Access Compliance Report

Public Rights-of-Way

Intersection ID: 13864	Main Street: 3RD-4TH_CONNECTOR_ST	Cross Street: CHARLOTTETOWNE_AV	Location: NE
ADA ID: 45CD8334FDDE	Ramp Type: PerpDiag	Initial Pass/Fail: Fail	Overall Compliance: No
Severity Score: 17.5			
Codes/Mitigation Info/Possible Solution		Field Measurements/Component Compliance

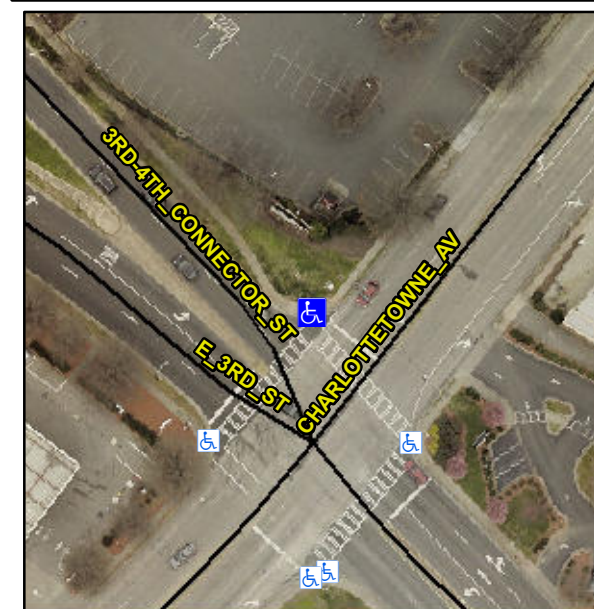
R304.5.1

Compliance	Description	Data	Compliance	Description	Data
N/A	Ramp Length (in)	58.0	Yes	Ramp Slope (%)	7.3
No	Ramp Width (in)	35.0	Yes	Ramp XSlope (%)	1.7
N/A	Flare Type LT	N/A	N/A	Flare Type RT	N/A
N/A	Flare Slope LT (%)	N/A	N/A	Flare Slope RT (%)	N/A
N/A	Flare Traversable LT?	N/A	N/A	Flare Traversable RT?	N/A
N/A	Landing Length (in)	N/A	N/A	DWS Provided?	N/A
N/A	Landing Width (in)	N/A	N/A	DWS Contrast?	N/A
N/A	Landing Slope (%)	N/A	N/A	DWS Length (in)	N/A
N/A	Landing X Slope (%)	N/A	N/A	DWS Full Width?	N/A
N/A	Landing Curb? (Y/N)	N/A	N/A	DWS Offset (in)	N/A
N/A	Shared Landing?	N/A			
N/A	Gutter Ponding?	N/A	N/A	Gutter Slope (%)	N/A
N/A	Gutter Lip Ht (in)	N/A	N/A	Gutter X Slope (%)	N/A
N/A	Painted X Walk1?	No	N/A	Painted X Walk2?	No
	X Walk 1 Direction	To SW		X Walk 2 Direction	To SE
N/A	X Walk 1 Width (in)	N/A	N/A	X Walk 2 Width (in)	N/A
	X Walk 1 Slope (%)	1.5		X Walk 2 Slope (%)	0.8
	X Walk 1 X Slope (%)	1.6		X Walk 2 X Slope (%)	1.8

Remove & Replace Curb Ramp With Two New Directional Ramps or Equivalent.
